CONCEPT DESIGN REVIEW

Northland Shipyard & Dry Dock

Concept Design Review

Northland Shipyard & Dry Dock – Concept Design Review

Figure 2: Proposed structures for the Northland Shipyard & Dry Dock facility

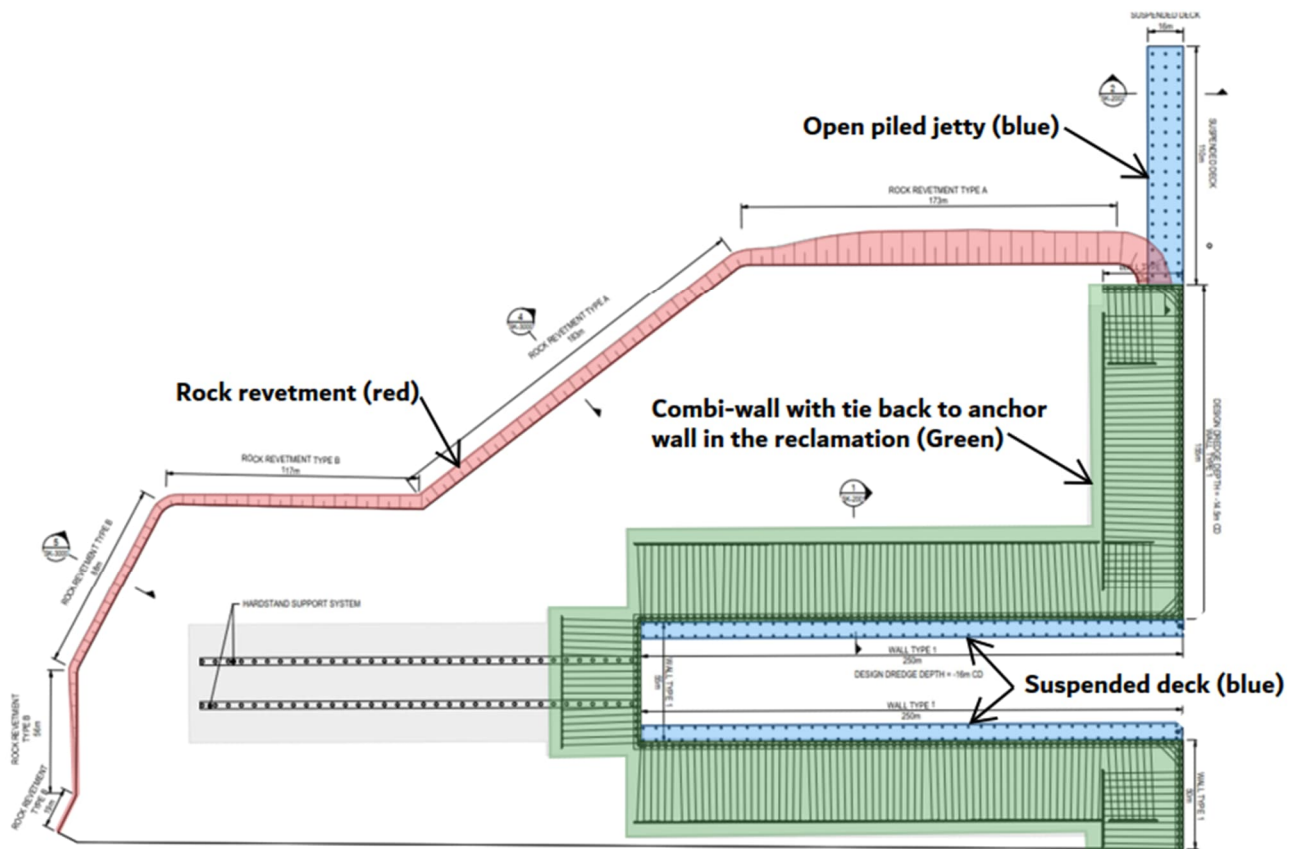
- It is an efficient method of reclamation construction.
- The soils are contained on site along with any contaminants.
- The size and shape of the reclamation is based on the operational needs at the site. The size of the reclamation provides flexibility for detailed design.

- The effectiveness of vibro-compaction is greatest in clean sands. Silts and clays interbedded within the dredged soils may make vibro-compaction ineffective. As part of detailed design, we recommend investigations of the dredge area to confirm the suitability of dredged materials for vibro-compaction.

- The proposed revetment/bund structure is a good solution as the geometry of the bund/revetment can be adjusted to respond to minor changes in User Requirements without necessitating a complete change in construction form.

- Cement mixing is not effective with sandy dredged soils. If the dredged material is not appropriate for cement mixing, material may need to be imported and used to construct the founding for the bund.

- The performance of the cementitious bund is sensitive to the local variability in the dredged material. As part of detailed design, we recommend investigations of the dredge area to confirm the suitability for use in the cementitious bund. If the dredged material is not appropriate for the cementitious bund, material may need to be imported.

- The seismic performance of the bund will be investigated during detailed design. Recommend at concept design that the proposed buildings near to the cementitious bund are piled.
- The depth of undercut required below the bund for stability is uncertain and could affect dredge and reclamation volumes.

- An open piled suspended deck structure is a good solution for the jetty and deck adjacent to the shiplift as this structural form can support large axial load demands.
- The geometry can be adjusted to respond to minor changes in User Requirements without necessitating a complete change in construction form.
- Durability requirements can be readily addressed using proven technologies.
- It is a simple construction procedure and easy verification of geotechnical capacity.
- Additional geotechnical investigations are required prior to detailed design to better estimate founding depth for the piles to achieve the required axial capacity.
- Hard founding (rock) is not expected to be found at the site. Piles can be readily lengthened to achieve required load capacity.
- Can be detailed to be resilient in earthquakes

- The combi-wall is a good solution as it enables vessels to berth alongside the wall whilst containing the dredged reclamation material behind the wall.
- The geometry can be adjusted to respond to minor changes in User Requirements without necessitating a complete change in construction form.
- Durability requirements can be readily addressed using proven technologies
- Has a simple construction procedure

Based on our review, the concepts for reclamation and marine structures are an appropriate and viable engineering solution.

Figure 13: Example of east-west transverse section vertical displacements

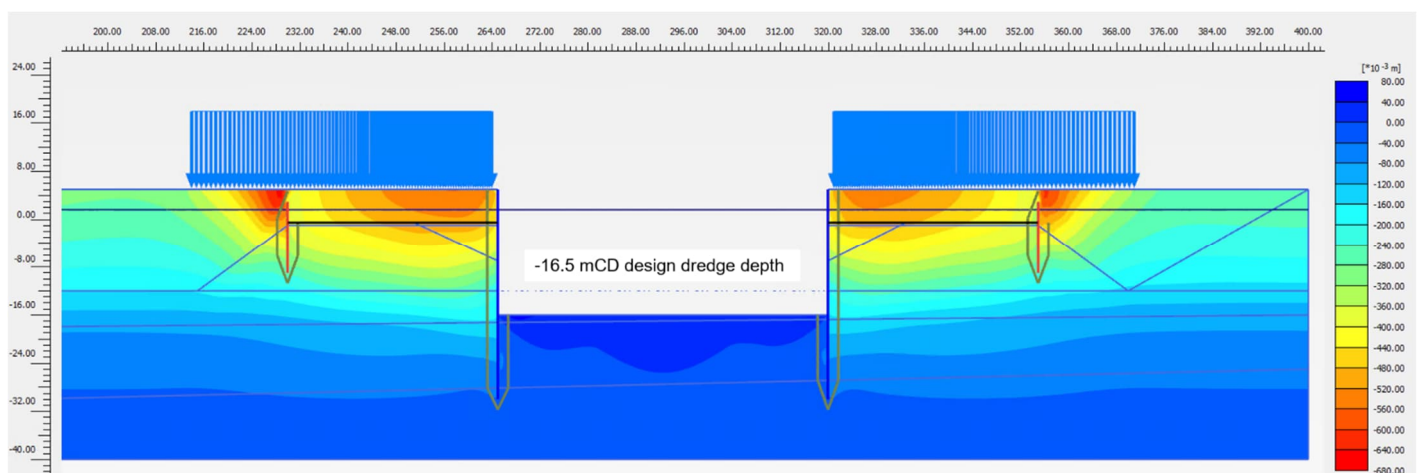
Calculated total vertical displacements from the construction of the reclamation fill and drydock are anticipated up to 400-700 mm behind the Combi-wall and Deadman. Much of the settlement will occur during the construction of Combi-wall and reclamation. The calculated total horizontal displacements at the top of the wall are expected to 200-400 mm.

Figure 19: Lateral displacements (U_x), shear forces (Q), and bending moment (M) of Combi-wall for north-south long section

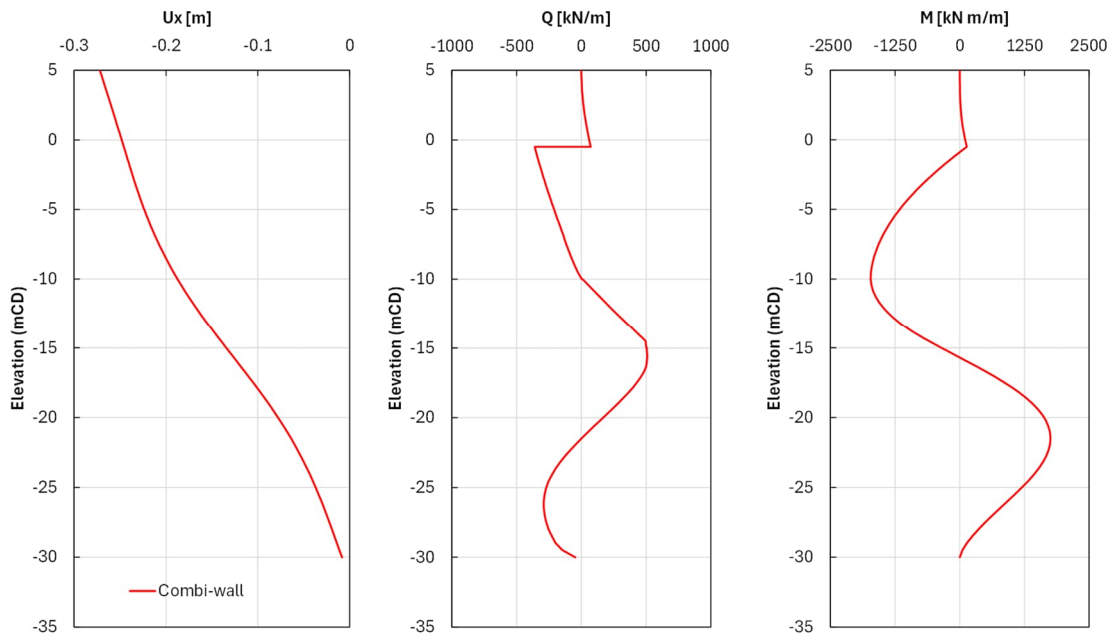
The factored structural demands on the Combi-wall and Deadman are within capacity when corrosion is not considered. However, allowing for corrosion and other factors could significantly reduce that capacity. We note that Beca's conceptual design report states that a cathodic protection system and corrosion protection system where CP is not effective is expected to be included in the final design.
